PROPOSED ARCHITECTURAL SKETCH FOR:
RESTAURANT & BAR
668 VERNON AVE
GLENCOE, IL 60022

#668 Vernon Ave. Glencoe.
FACADE APPLICATION

EXTERIOR APPEARANCE REVIEW APPLICATION

SUBJECT: **Staff Memo – 668 Vernon Ave. Exterior Appearance Review**

GRAPHICS ON NORTH WALL
FOR REFERENCE ONLY

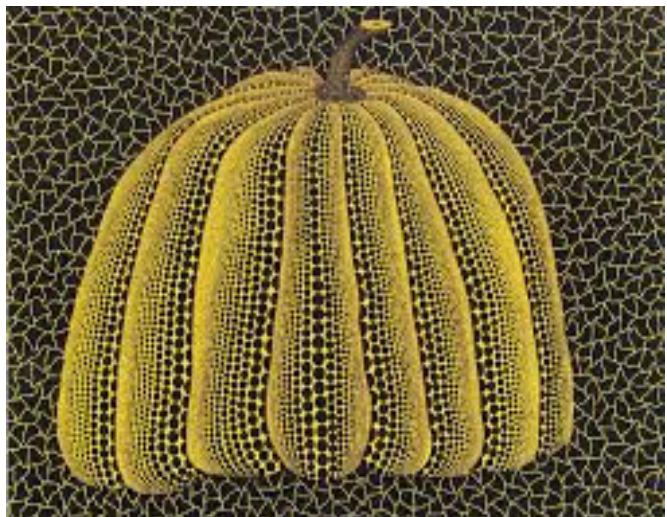
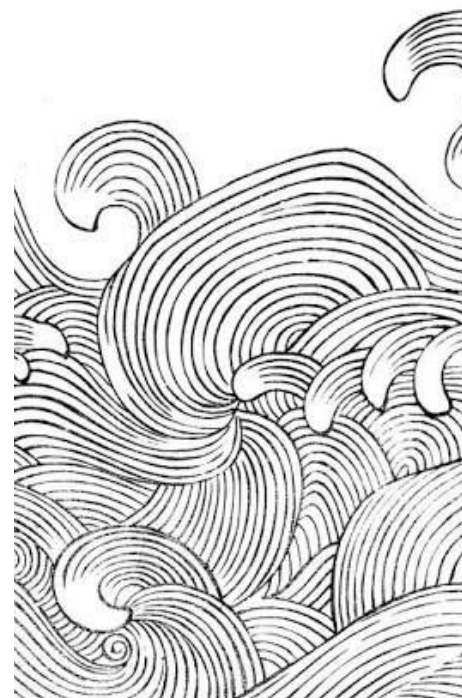
The applicant has proposed a mural on an approximately 750-square-foot section of the north wall of the building. As proposed, this would add interest to the public realm along Vernon Avenue. However, the applicant has stated that the mural is conceptual in nature and subject to change. A final proposal that differs significantly from that shown in this location would need to come back to the Plan Commission for exterior appearance review. Any mural that contains commercial advertising would not be permitted under the requirements of the sign code.

Rear garage door will be replaced with a single door. fill in area with brick, tuck-point and paint to match north facade

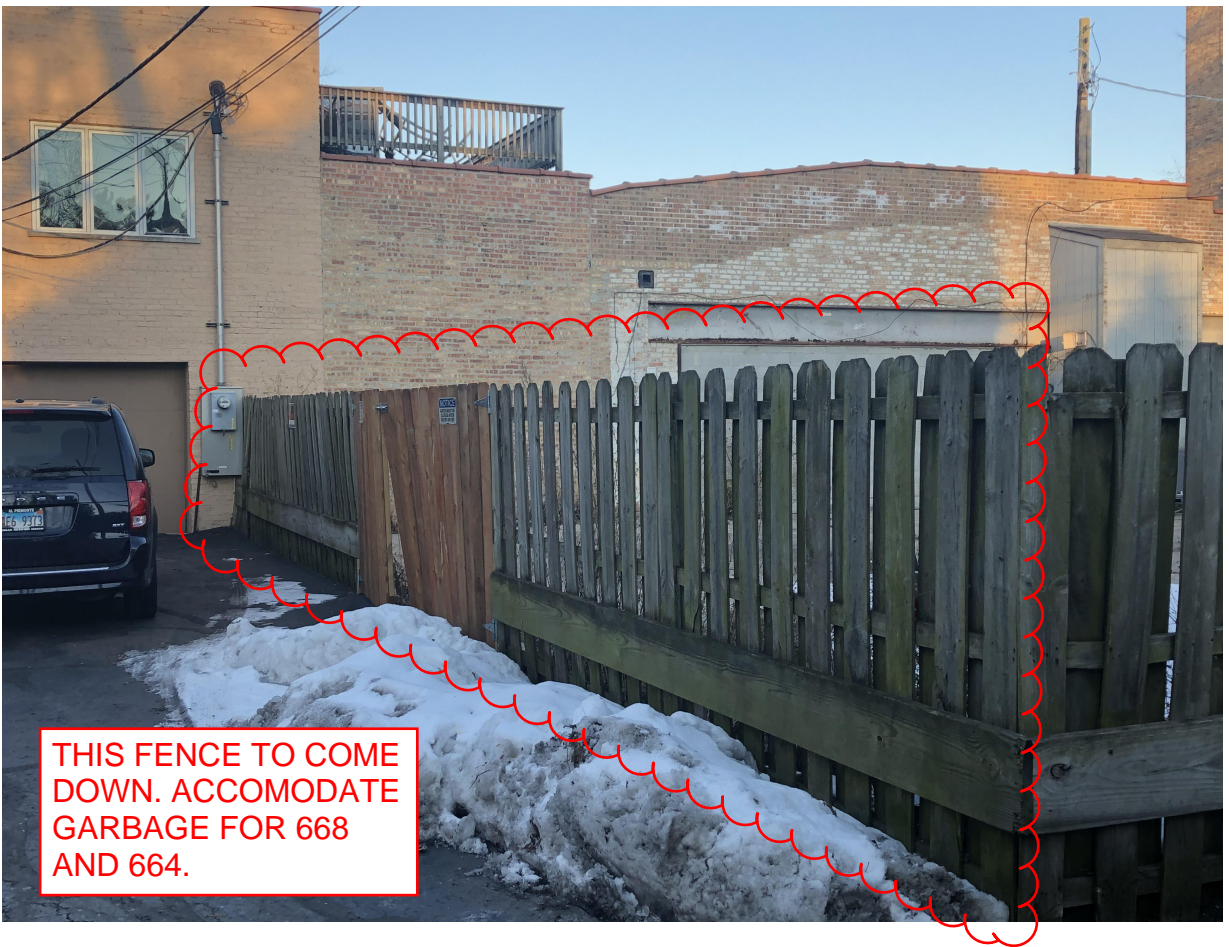
The building has a service entrance accessible via the alley to the rear, which meets the guideline of “minimizing the visibility and impact of service areas by locating areas and service access away from primary building access points”. However, the applicant has proposed a new shared garbage area to the rear of the building and the removal of the fence extending from the rear of the building. The Design Guidelines include a recommendation to “screen trash enclosures”. While dumpsters are currently visible at the rear of the building, this renovation may be an opportunity to provide better screening for the benefit of adjacent properties to the north.
